CITY OF SAN ANTONIO

Re: Friesenhahn (Amendment) MDP# 802-A

The City Staff Development Review Committee has reviewed Friesenhahn (Amendment) Master Development Plan M.DP# 802-A, please find enclosed a signed copy for your files. Your plan was accepted however please note the following:

FRIESENHAHN
MASTER DEVELOPMENT PLAN

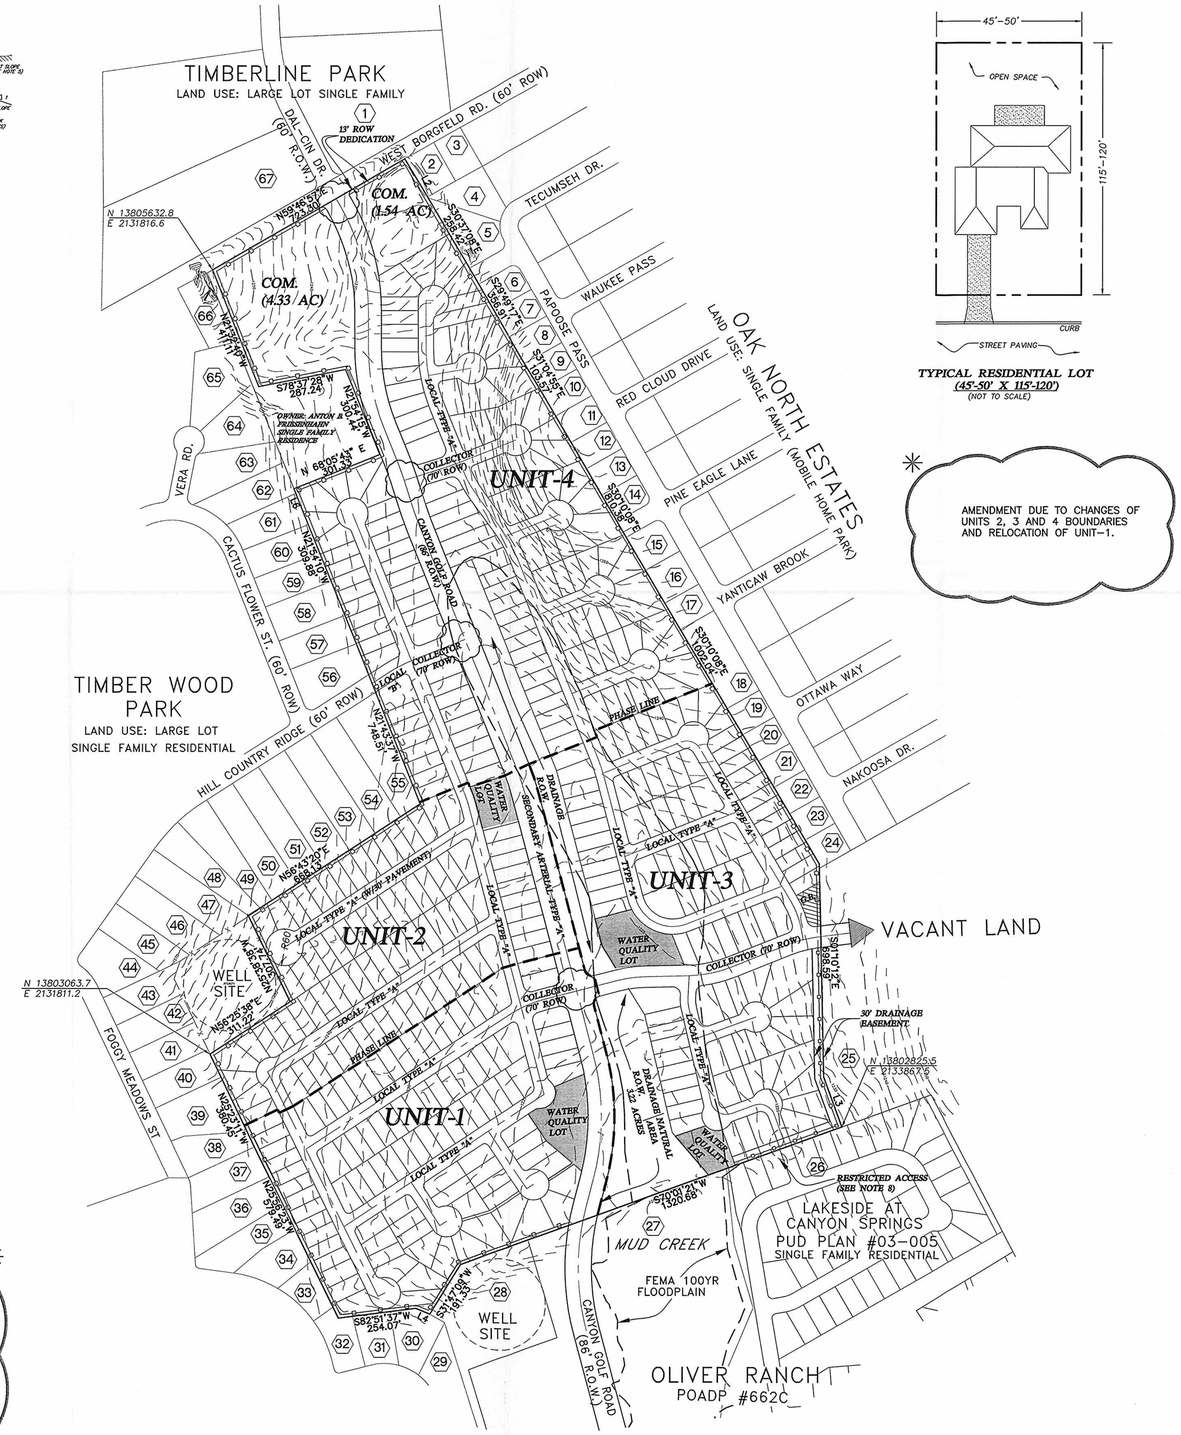
1. The above referenced MDP is approved with the following condition: Remove all specific reference to pavement structure on the secondary arterial typical street section. Utilize generic labeling for surface course, base course and subgrade.

a. Evaluate the potential need for drainage interceptors with easements in the southeast corner and along the midwest boundary of the development.
     b. Evaluate potential street grade issues on several cul-de-sacs in the northeast sector and on the northern portion of Canyon Golf Road.
